Wates Developments
Land adjacent to Deeping Road, Baston, Lincs

Formal Response to Consultee Comments

July 2026 (Revision A)

LAND ADJACENT TO DEEPING ROAD, BASTON, LINCOLNSHIRE
FORMAL RESPONSE TO CONSULTEE COMMENTS
JULY 2026 (REVISION A)

DRAWN BY			
NAME (PRINT)		DATE	
CAB		23.02.26	
CHECKED BY			
NAME (PRINT)		DATE	
CJB		23.02.26	
SCALE AS SHOWN		STATUS	PRELIMINARY
DRG. NO. F20159/06			REV C

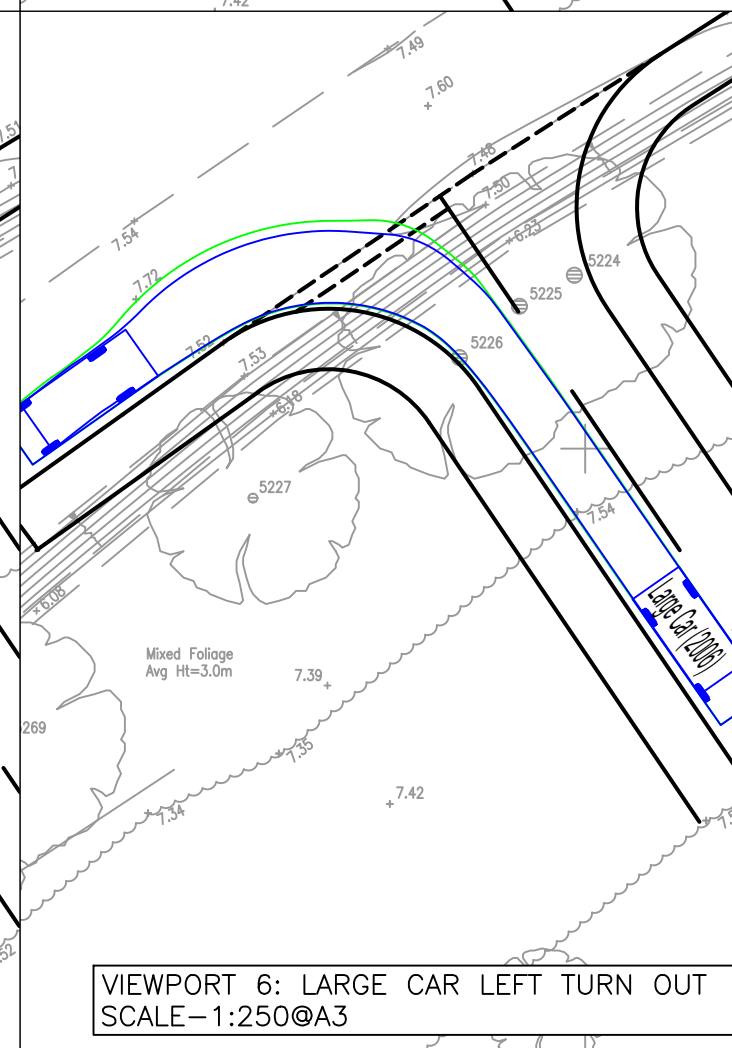
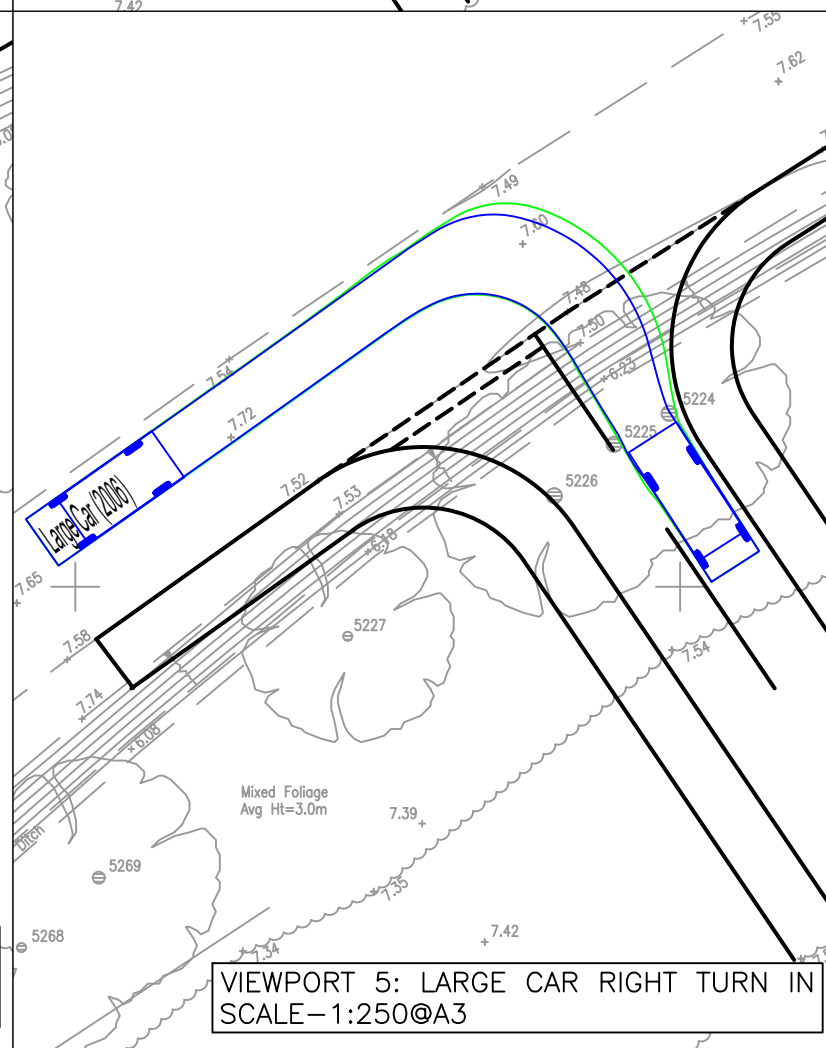
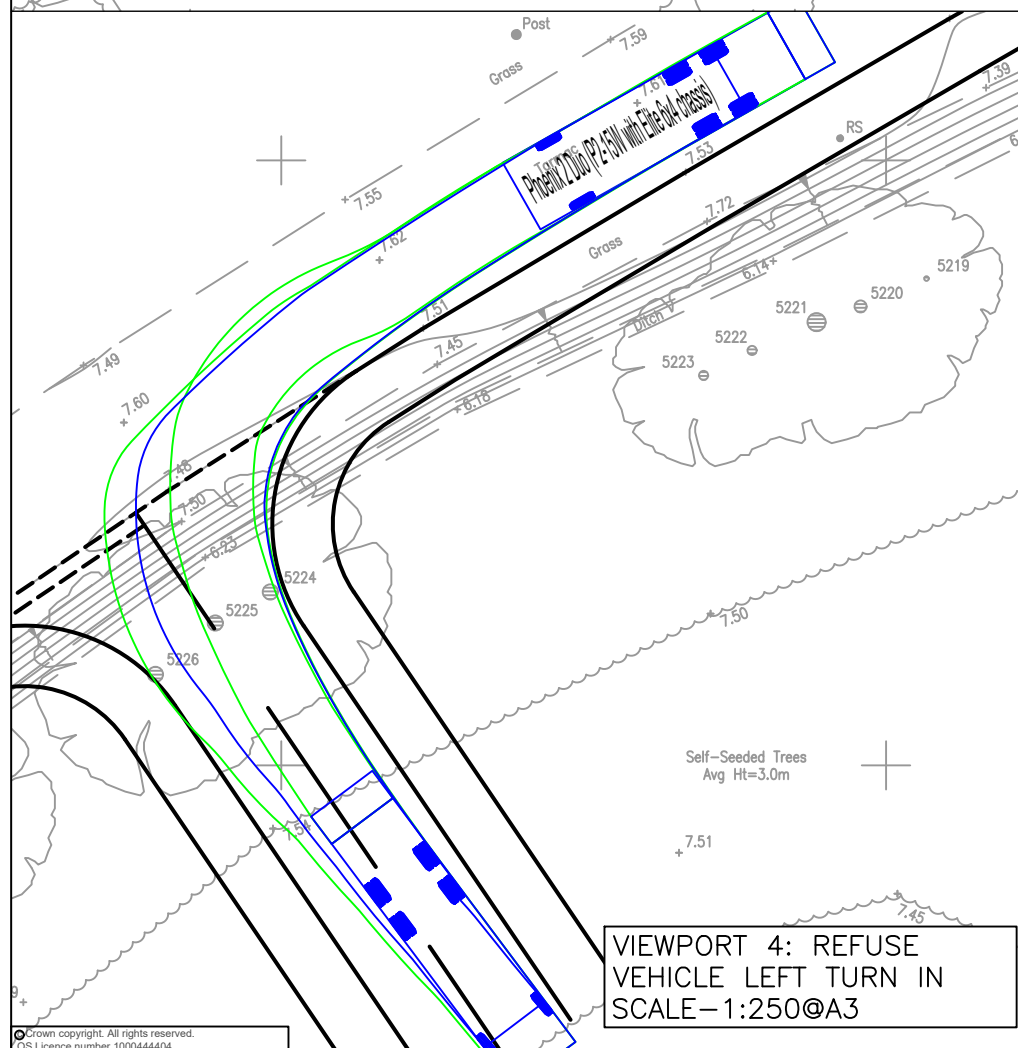
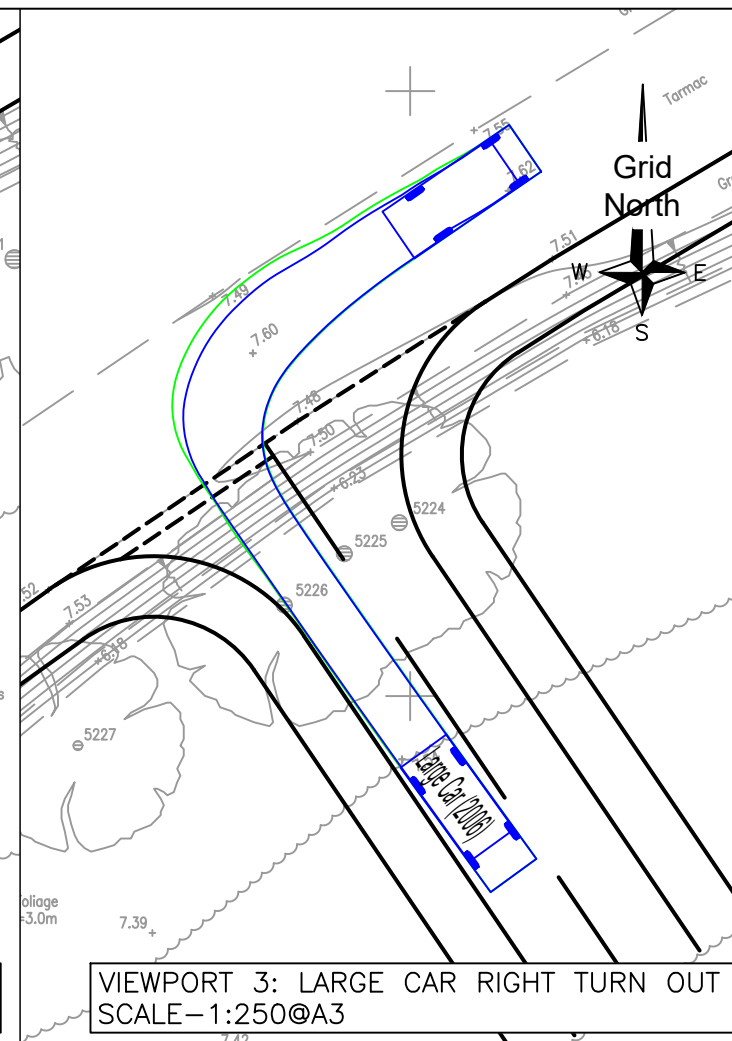
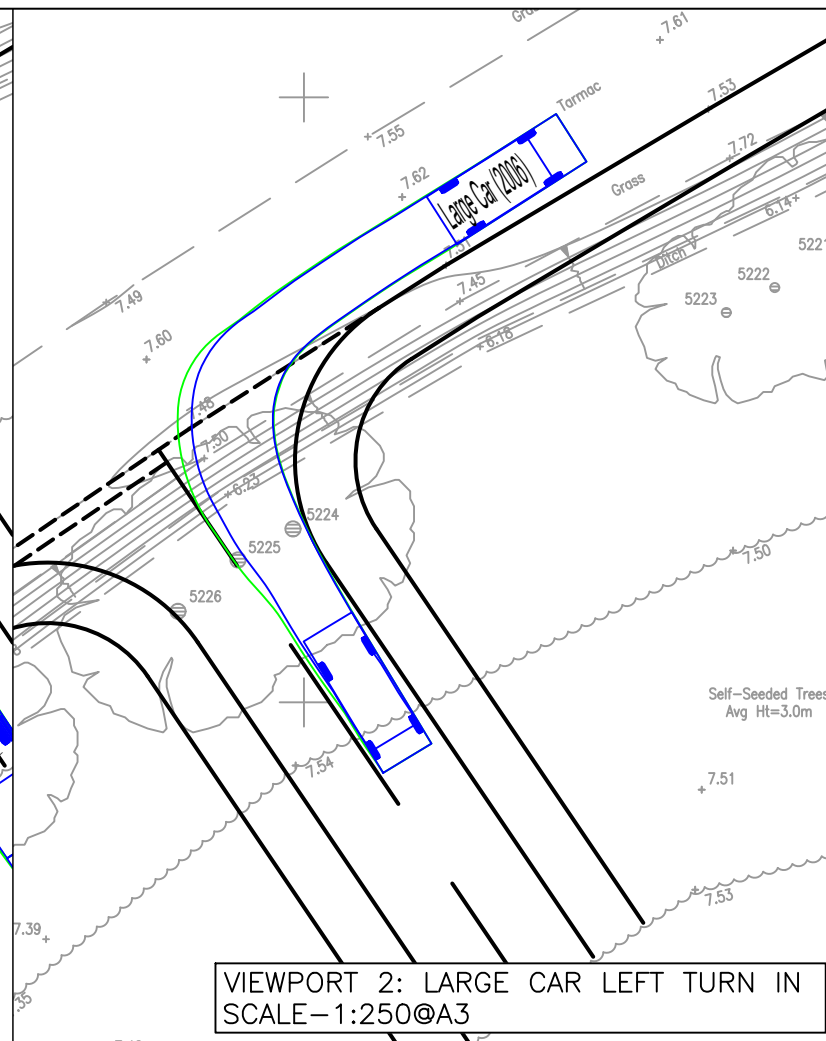
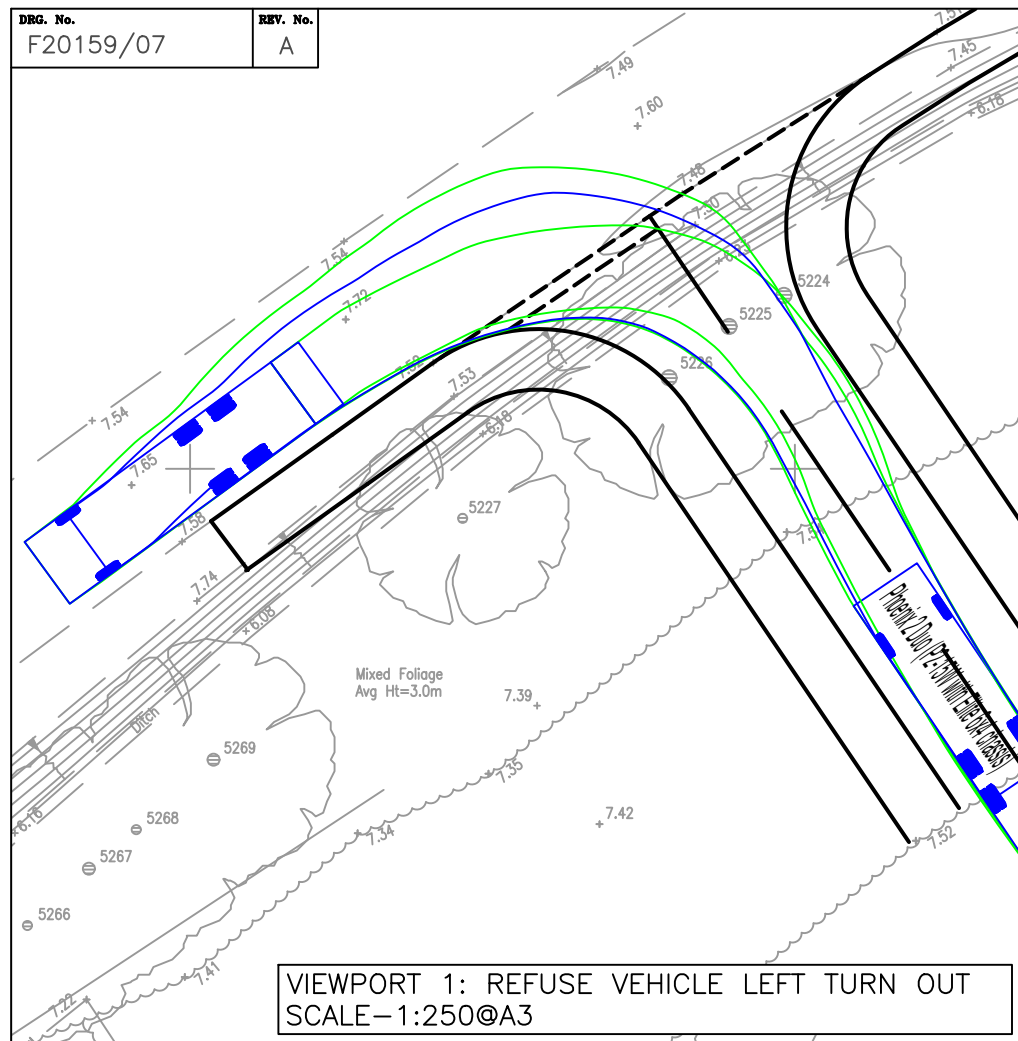
LCC Comment	BCL Response/Action
Footway/cycleway to terminate at Maltby Drive junction (A15).	<i>It will not be possible to extend the footway/cycleway up to Maltby Drive due to third party land constraints. However, Drawing Number F20159/06 Revision C now shows how a 1.8 metres wide link would extend north to connect with the existing facilities at the junction.</i>
The plan needs to show where the carriageway is being widened to accommodate the GIRTl.	<i>Noted. This is shown in the new Drawing Number F20159/14.</i>

- **Drawing Number F20159/06 Revision C** – amended to include 5 metres wide access, footway extension to Maltby Drive, and labelling for future streetlighting.

4.5 While ATE is generally satisfied with the proposed street sections in the DAS, it is essential that these sections are consistent with access arrangements. Please see comments in 3.7.	<i>Following discussions with the Highway Authority, it has now been agreed that the proposed internal road layout would comprise a 5 metres wide carriageway between each of the proposed site access junctions. Drawing Number F20159/03 Revision C and Drawing Number F20159/06 Revision C show the updated layouts for Greatford Road and Deeping Road respectively.</i>

DRG. No.
F20159/08

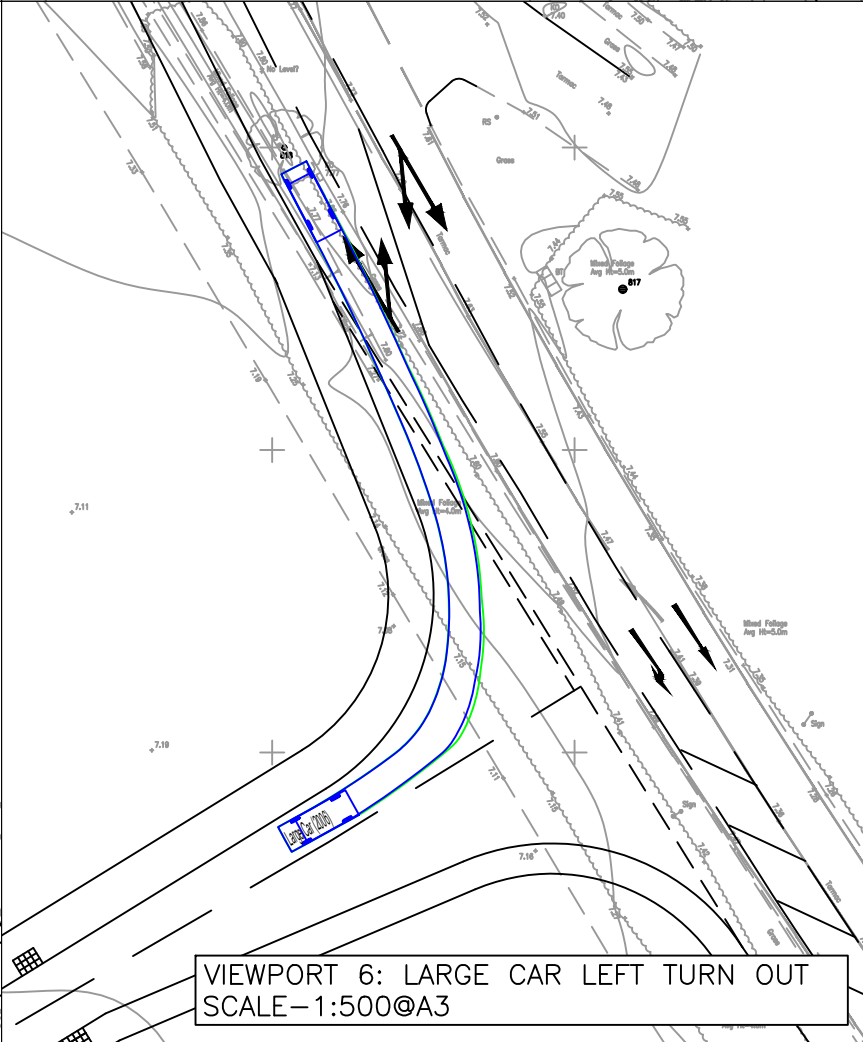
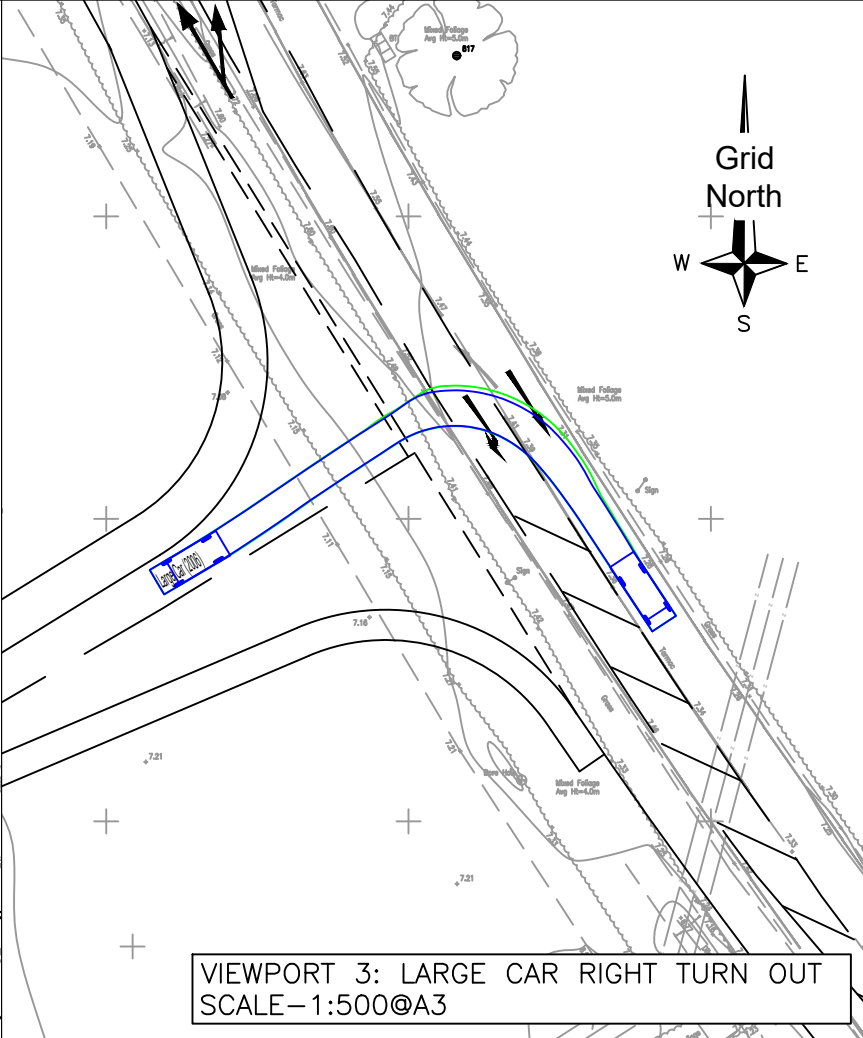
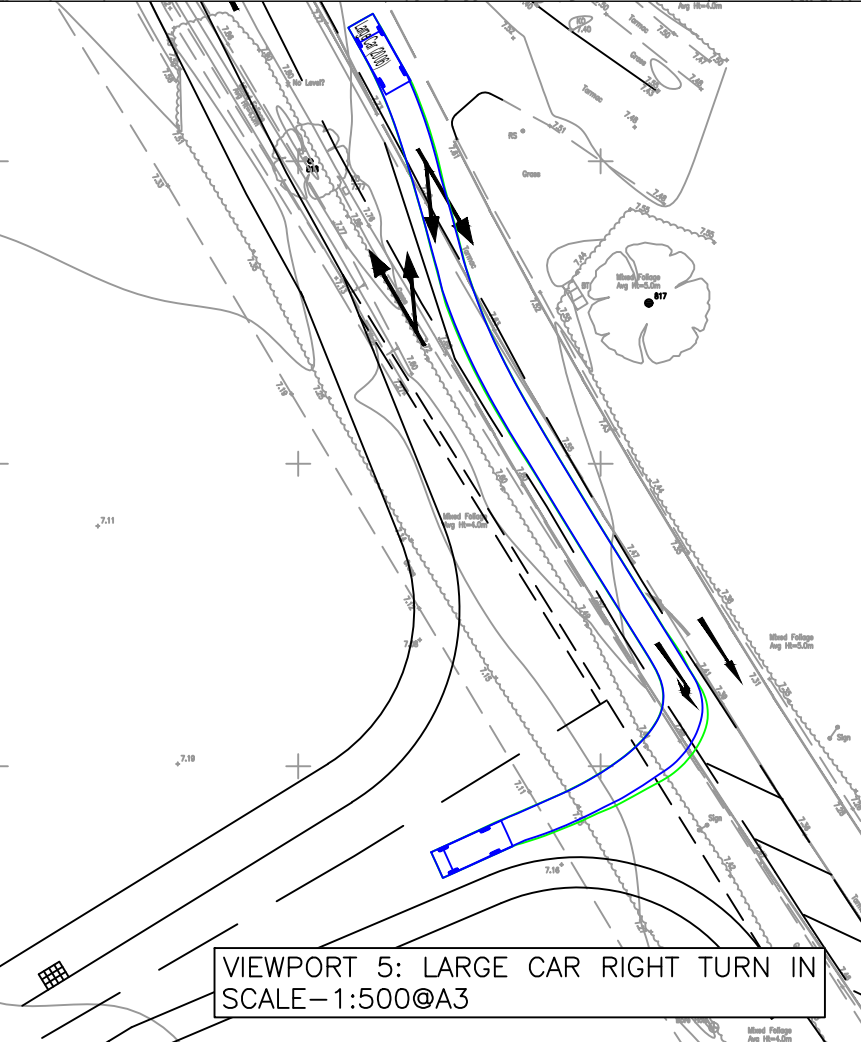
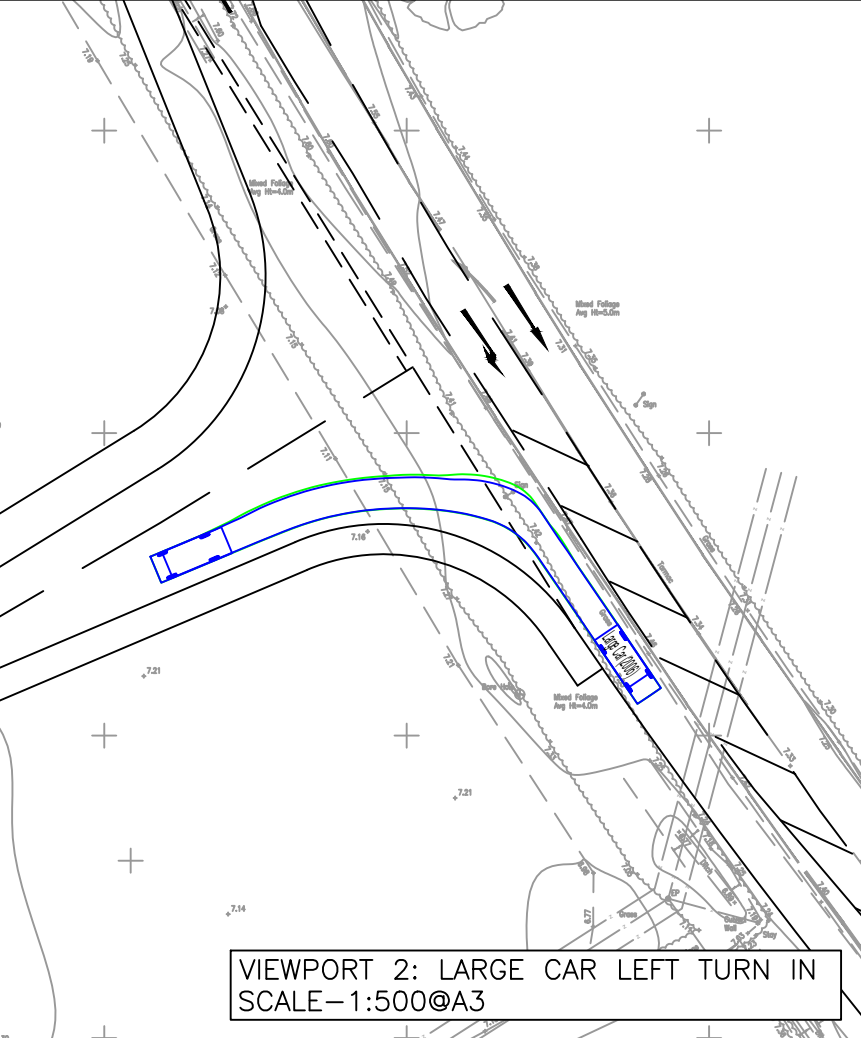
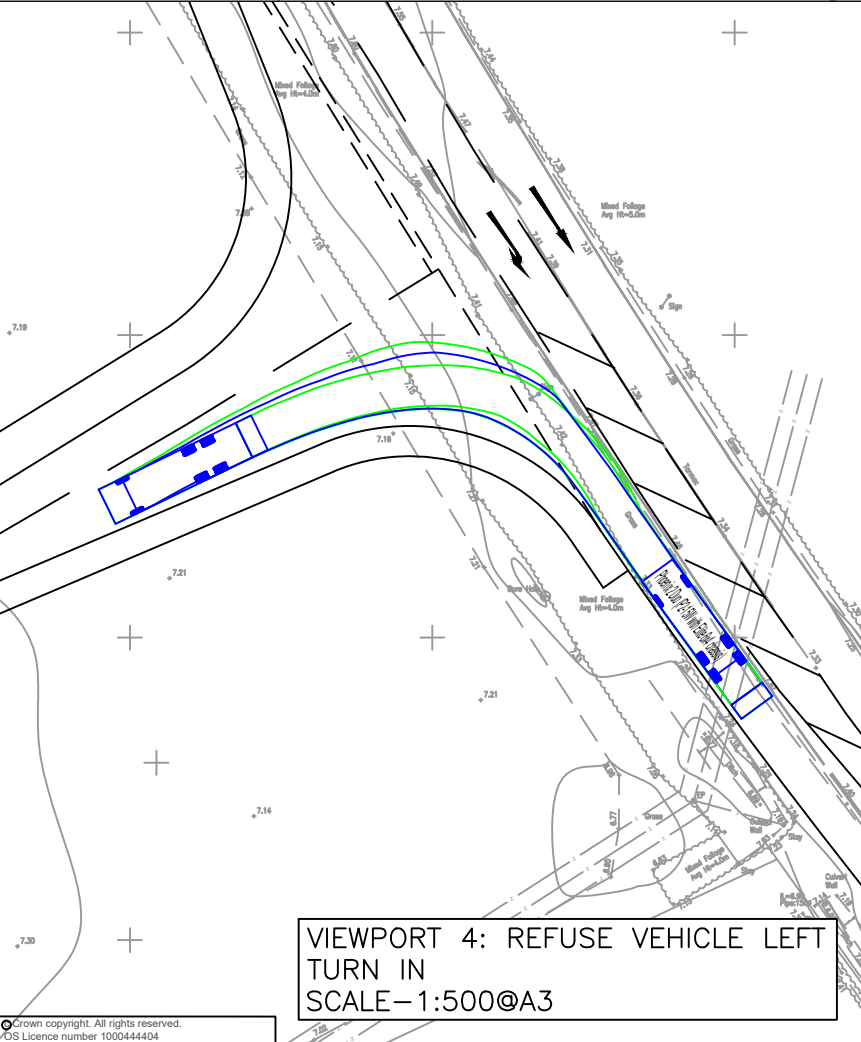
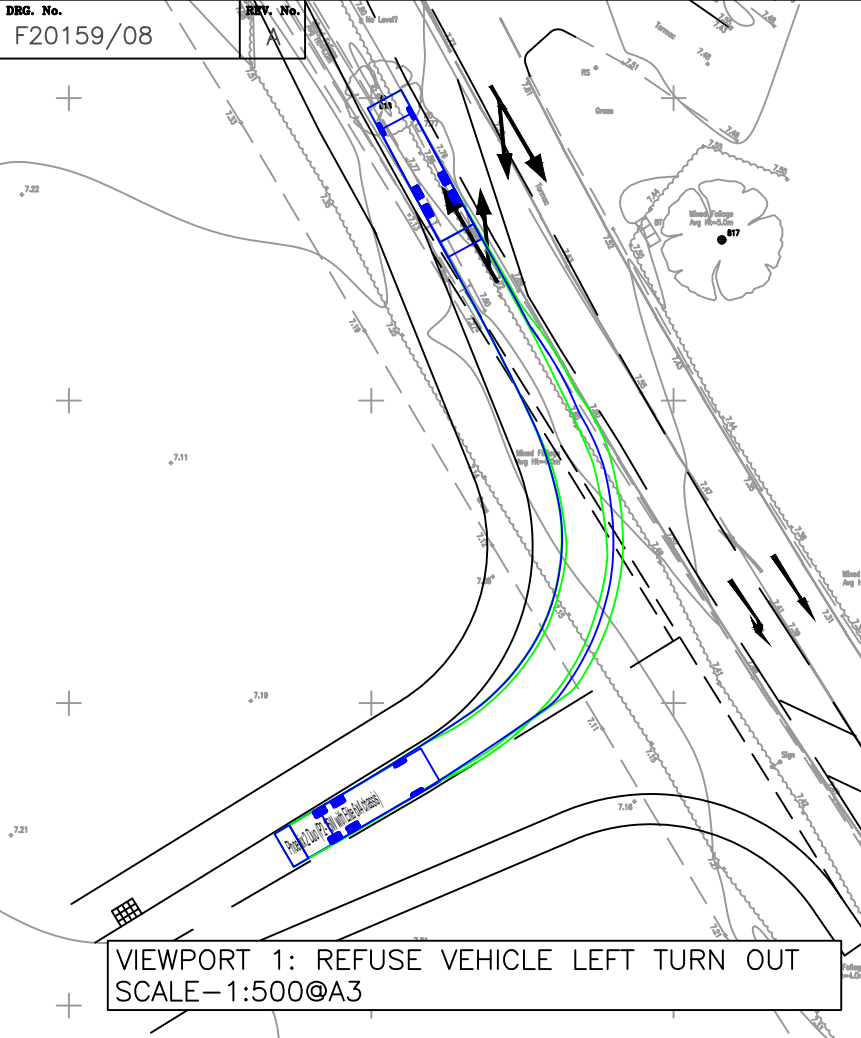
The principles of drainage for the highway improvements need to be detailed.	<i>Noted. Details to be provided at detailed design stage, secured by way of planning condition.</i>
Swept paths are required for the GIRTLS.	<i>Noted. Drawing Number F20159/11 now shows the tracking of a large refuse collection vehicle turning right into the site via the updated right turn lane arrangement.</i>
Pre-app discussions suggested improvements to King St Junction, but nothing has been detailed - improve connections to the PROW here.	<i>Section 9.4 of the Transport Assessment calculates how the proposed development would generate up to 6 hourly pedestrian movements, or 11 if bus movements are included too. These would primarily be associated with areas to the north and east of the site and are not expected to pass through the King Street / Greatford Road junction. Hence, in line with Paragraph 58 of the NPPF there are no proposals to deliver pedestrian infrastructure to extend the footway provision west of the proposed Greatford Road / Site Access junction.</i>

- **Drawing Number F20159/07 Revision A** – amended to address updated Greatford Road site access layout.
- **Drawing Number F20159/08 Revision A** – amended to address updated A15 site access layout
